Document Information			
Document #	0201741/02-RCA-0272	Revision	
Title	QUARTERLY NOTIFICATION OF CLASS 1 MODIFICATIONS TO THE HANFORD FACILITY RESOURCE CONSERVATION AND RECOVERY ACT (RCRA) PERMIT, DANGEROUS WASTE PORTION (QUARTER ENDING MARCH 31, 2002 - PERMIT CONDITION I.C.3)		
Date	04/09/2002		
Originator	J. HEBDON, R. H. GURSKE, R. D. (ROBY) <i>ENG E</i>	Originator Co.	DOE, FH, PNNL
Recipient	L. E. RUUD	Recipient Co.	DOEC
References			
Keywords			
Projects			
Other Information

FMP-CS (Facility Modification Package - Coversheet) (Block 17, 18, 22)*

1. Mod Title: Change to ECN-664331			
2. USQ Required? USQ # _____ N/A _____ CX # _____ N/A _____		3. Assigned Lead Engineer: H.L. Roach	4. Design Authority: S.T. Willett
5. Project No./Work Package No.: EL-00-00712/M	6. Area 200E	7. Building 2025E	8. System No.: 60J
9. Related FMPs/Changes:	10. Incorporates ECN/DCNs:	11. Contract Mod. No.:	12. Change Proposal No.:
13. Lead Engineering Discipline:	14. Affected Engineering Disciplines:

15. Change Description (description and reason for requested change):
 Drain pipe upstream of valve 60J-107 needs to be capped. A detail is provided for capping this drain with applicable changes to th

H 2 817974, Sheet 1, Rev. 2, Zone C 7 to D 7

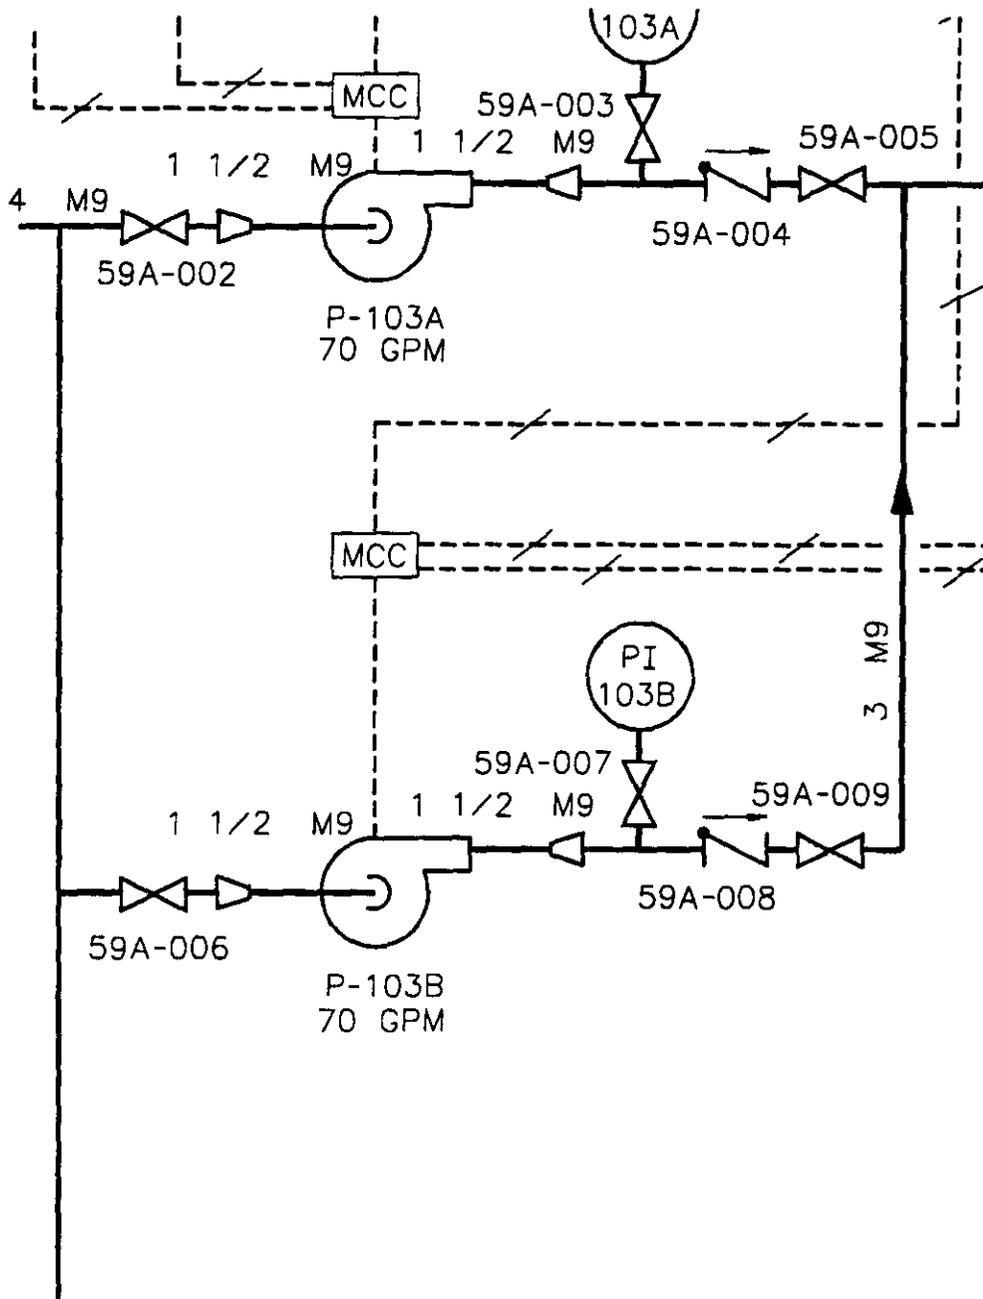
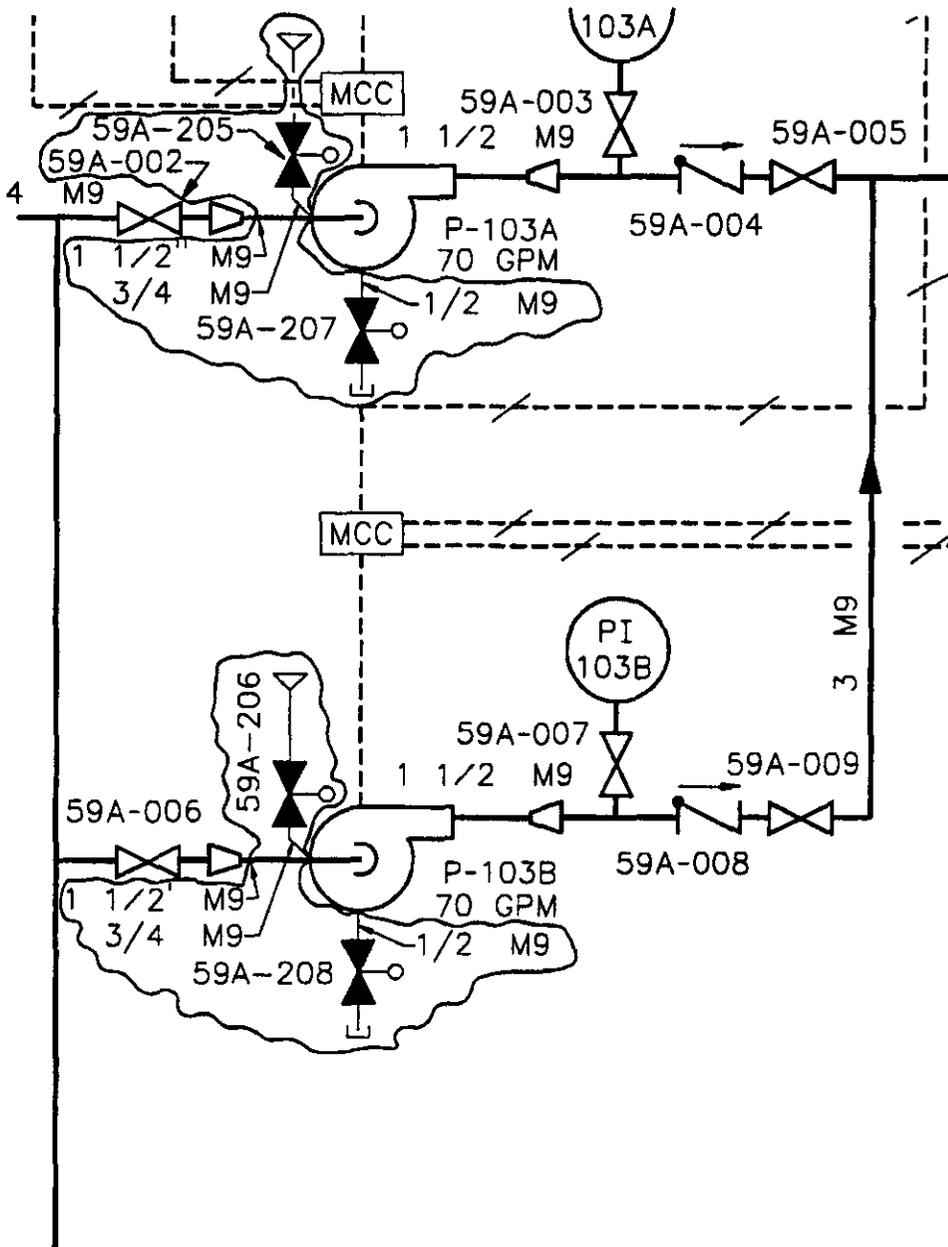
- Remove flow orifice in System 60M transfer line from Load In Station
- As build sample valve and tanker vent valving
- Add drain lines and valves to Load In Station pump cases
- Add bell reducer funnels and valving to suction of Load In Station pumps
- Replace Facility with Station in all Load In drawing titles
- Identify status of Load In Station drawings to Essential or Support

ZN C-D/6-7

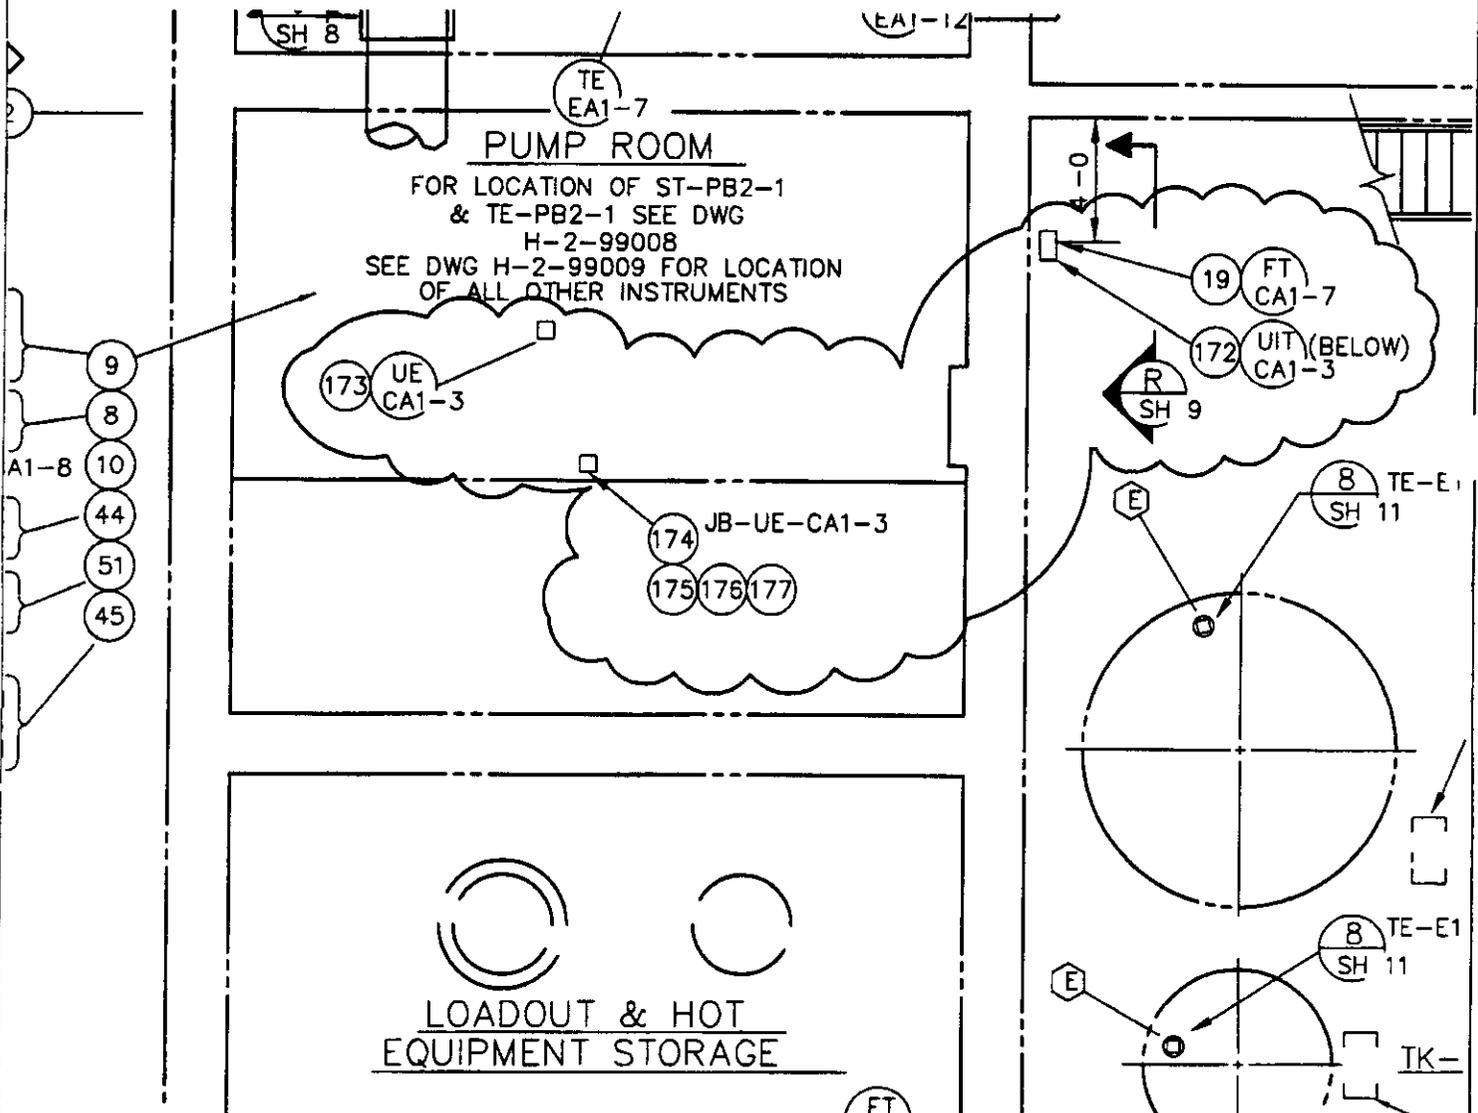
ADD NEW FLOW TRANSMITTER
(LOCATE BELOW EXST FLOW TRANSMITTER)

Ref Dwg H-2-99048	Sh 9	Rev 2	Prepared By K HALE	Check d By	ECN N 664551	Page 5
----------------------	---------	----------	-----------------------	------------	-----------------	-----------

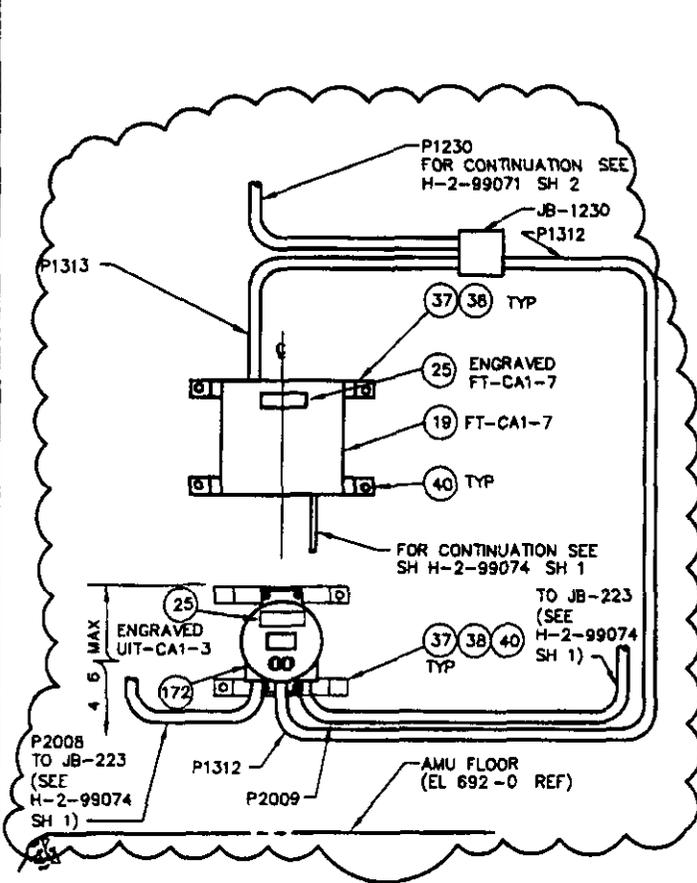
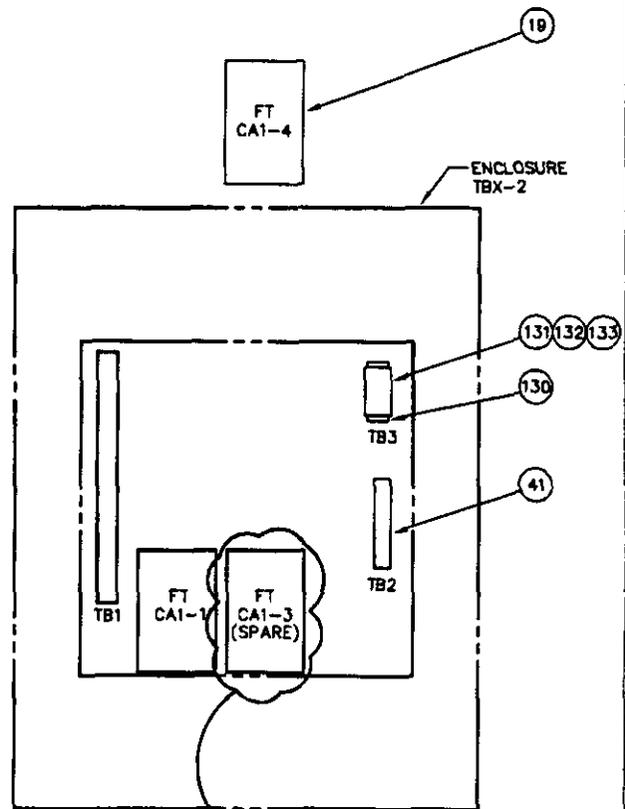
ADD NEW FLOW TRANSMITTER AND NAMETAG (LOCATE NEW TRANSMITTER BELOW EXST FLOW TRANSMITTER) INTERCEPT EXST P1230 AS SHOWN
 EXST FT-CA1-3 IS TO BE REMOVED CONDUCTORS TO BE SPARE

Ref Dwg H-2-99009	Sh 1	R 2	Prepared By JR BYERS	Checked By	ECN N 664551	Page 14
----------------------	---------	--------	-------------------------	------------	-----------------	------------

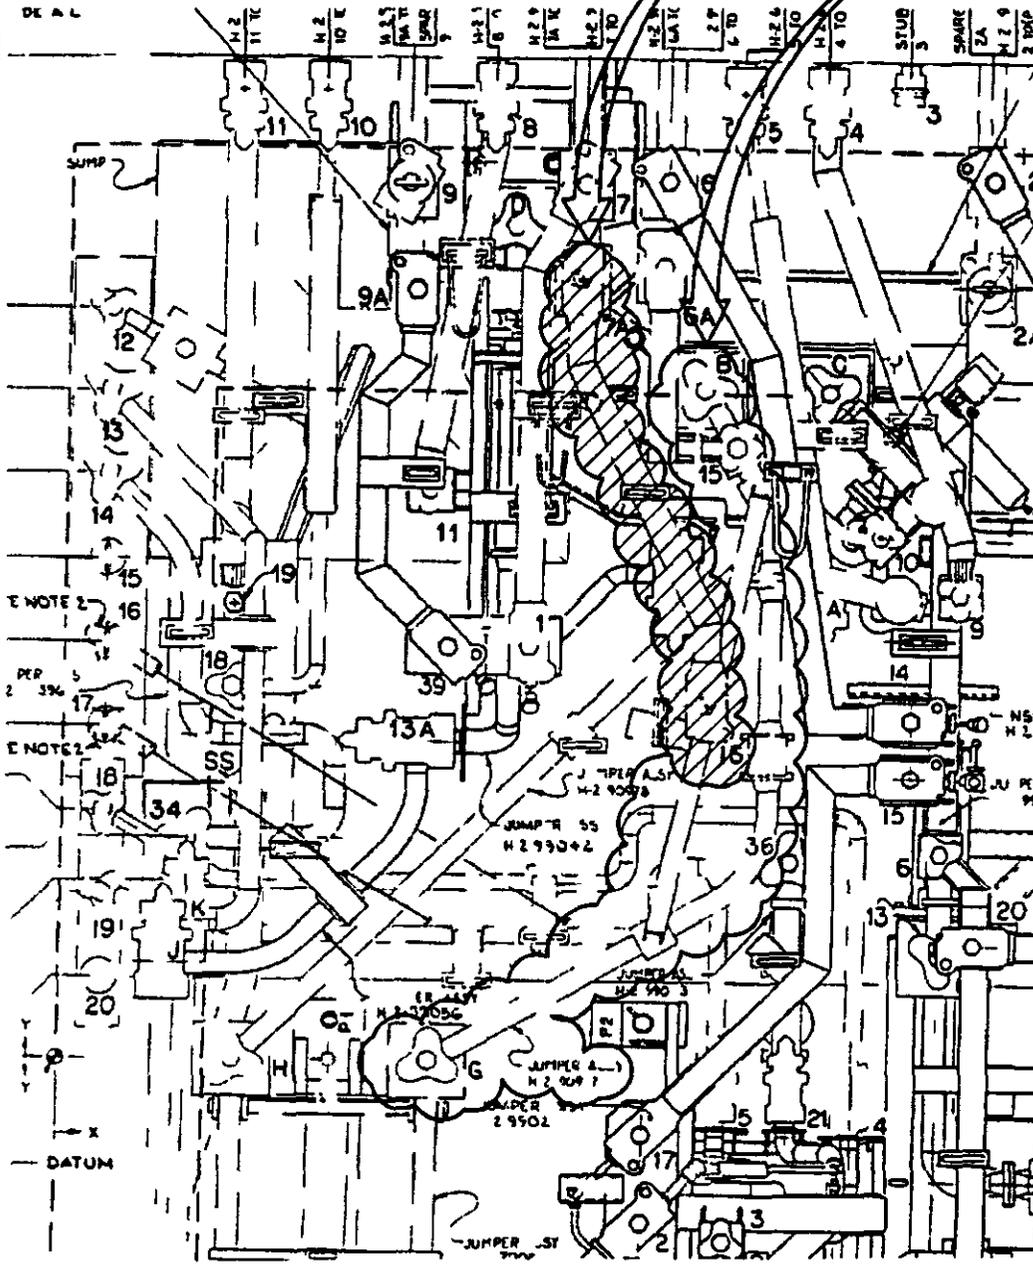
REMOVE ELECTRICAL JUMPER 7A-16
MODIFY JUMPER G-B (16) (15)
SEE PAGE 13

ZONE A-E/8

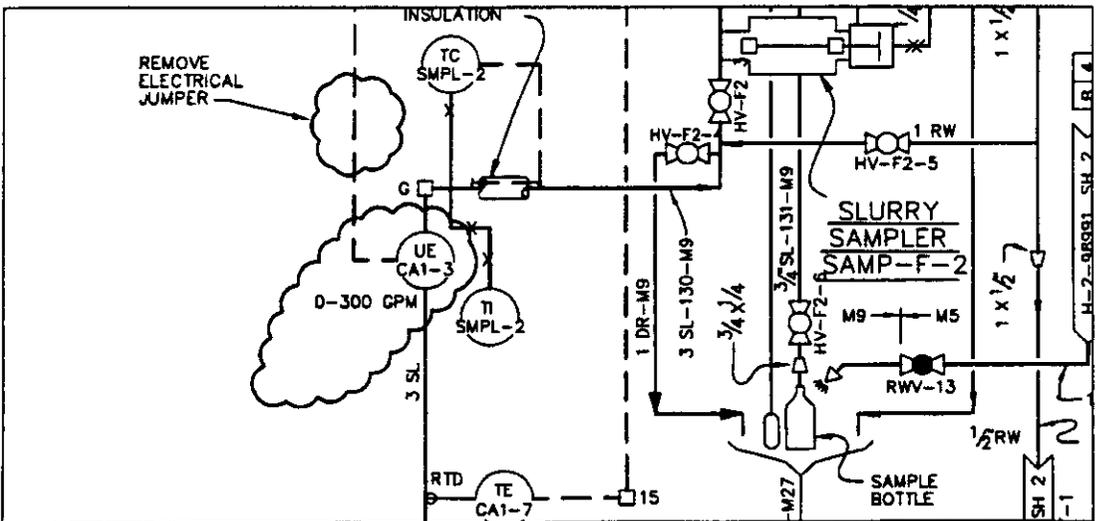
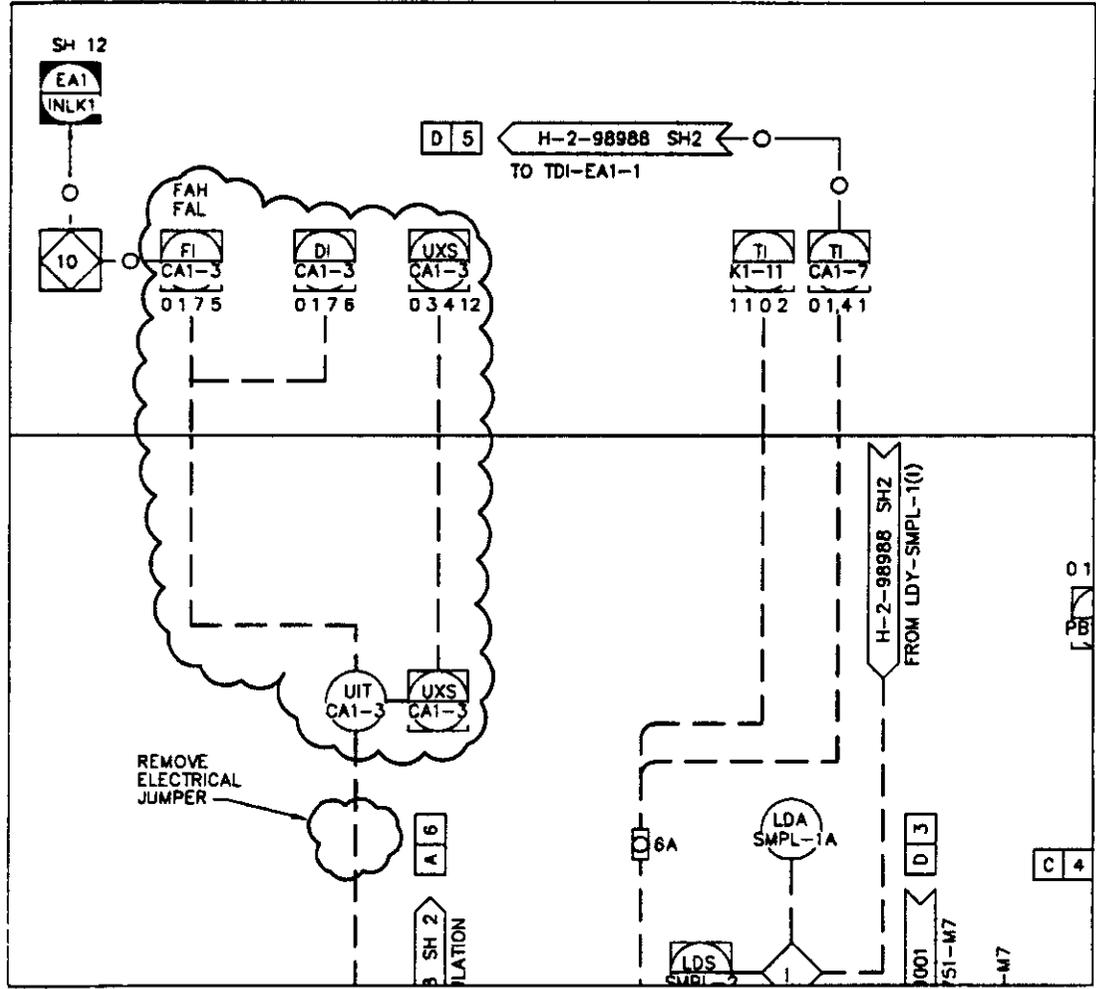
REVISE FLOW METER TAGS TO SHOW NEW FLOW MASS DENSITY METER/TRANSMITTER UE/UIT-CA1-3 NUMBERS

ZONE B/4

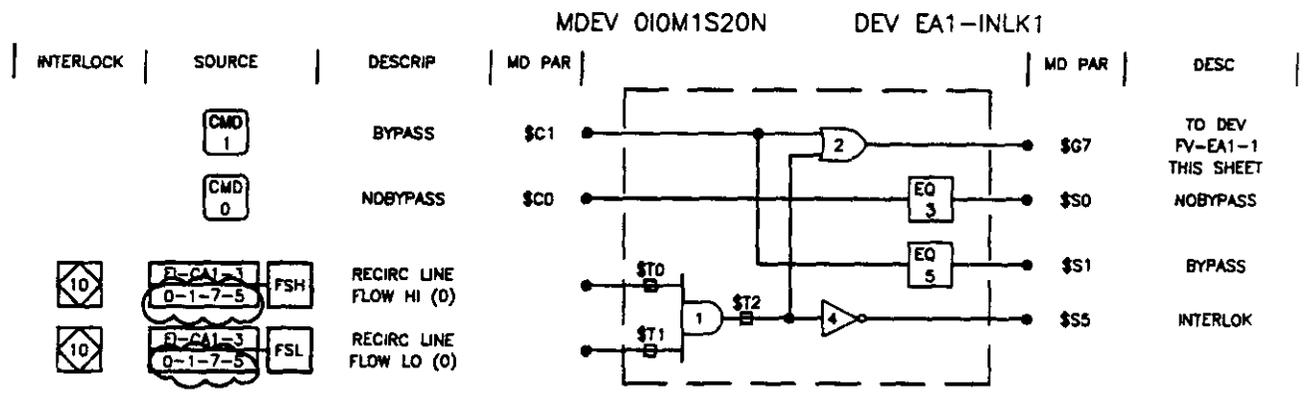
REVISE PCM MULTIPLIER BOARD AND POINT ADDRESSES ON LOGIC DIAGRAM

ZN C-D/6-7

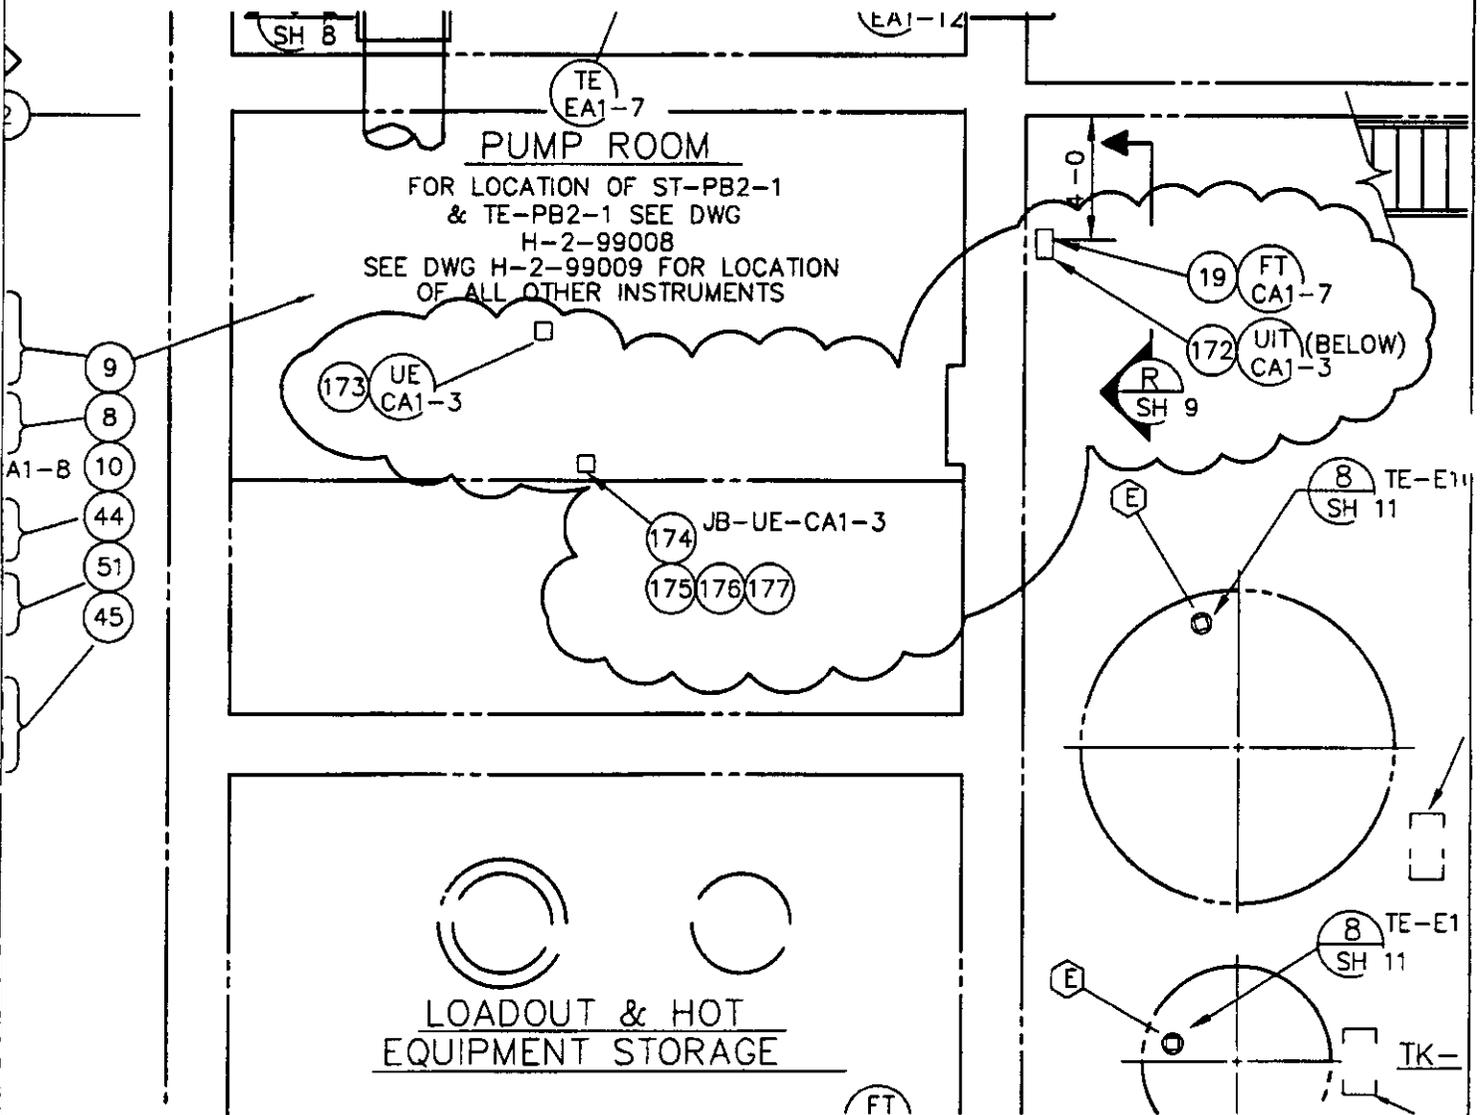
ADD NEW FLOW TRANSMITTER
(LOCATE BELOW EXST FLOW TRANSMITTER)
